**CHILDREN'S HOSPITAL
OF ORANGE COUNTY**
455 S. Main St.
Orange, CA 92668-3874

TOWER II

**LEVEL 4 ENLARGED PLAN
AREA - L**

A3.4L

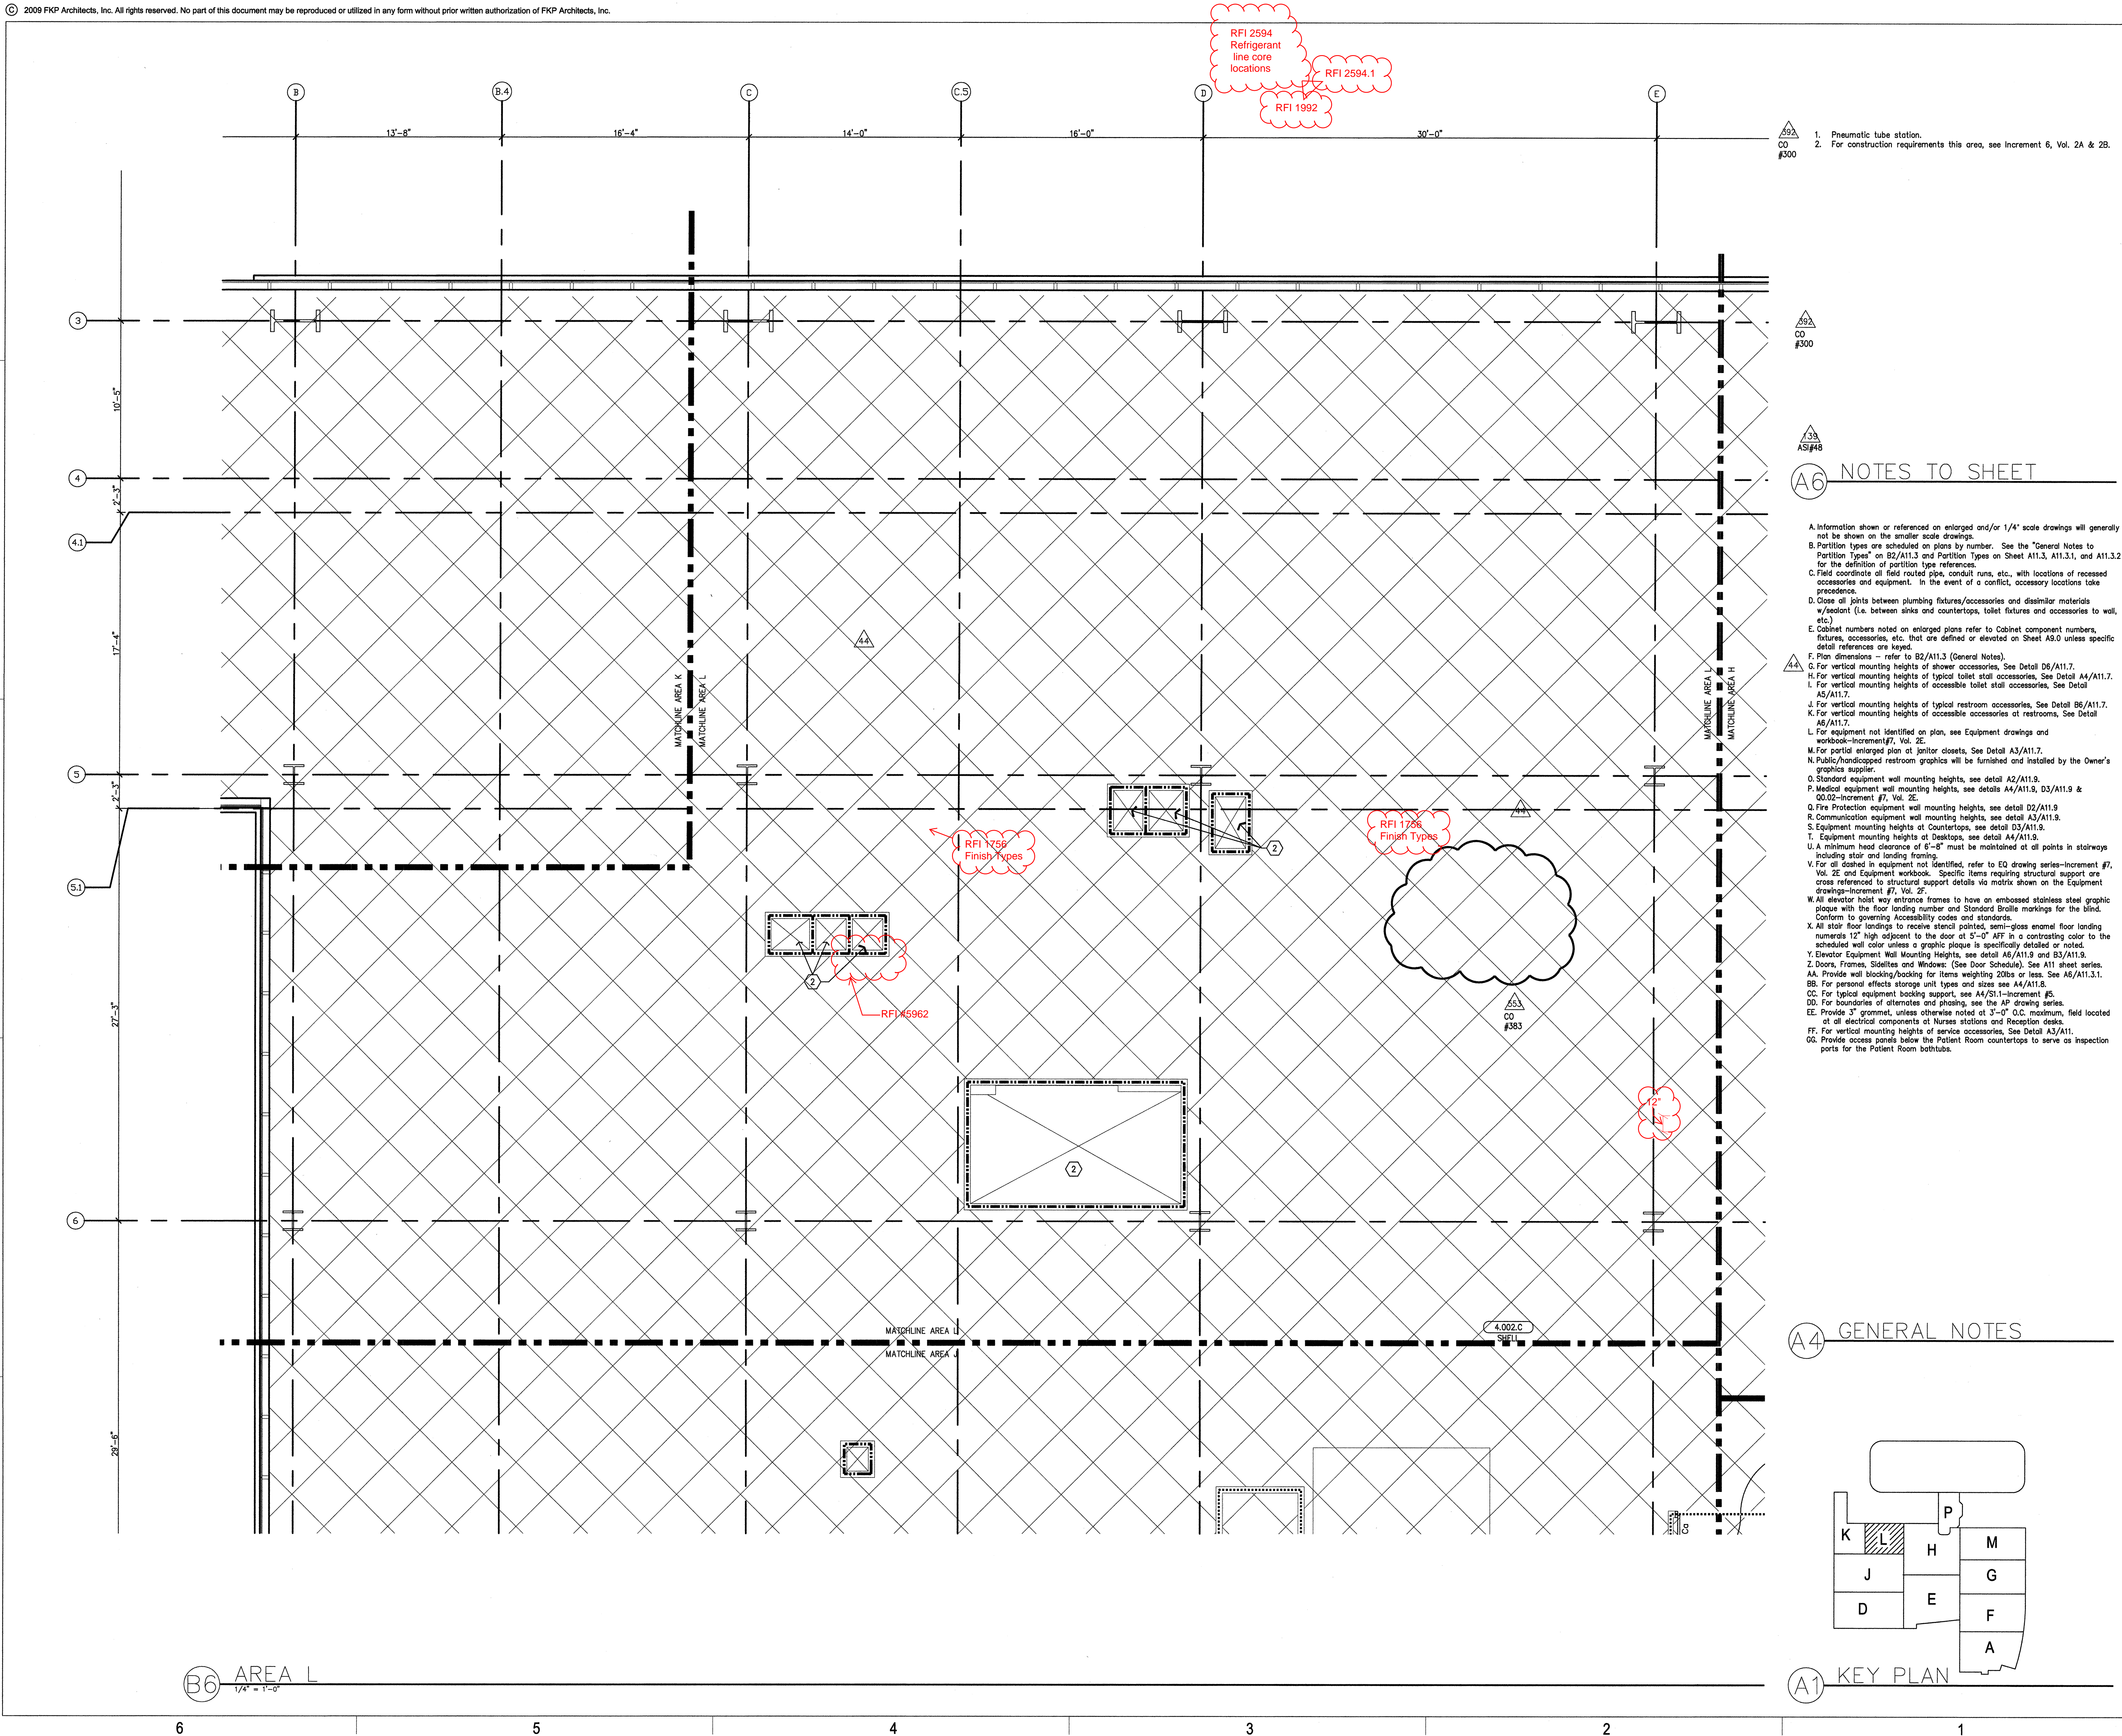
1. Pneumatic tube station.
2. For construction requirements this area, see Increment 6, Vol. 2A & 2B.

1. ASI #48
2. ASI #48
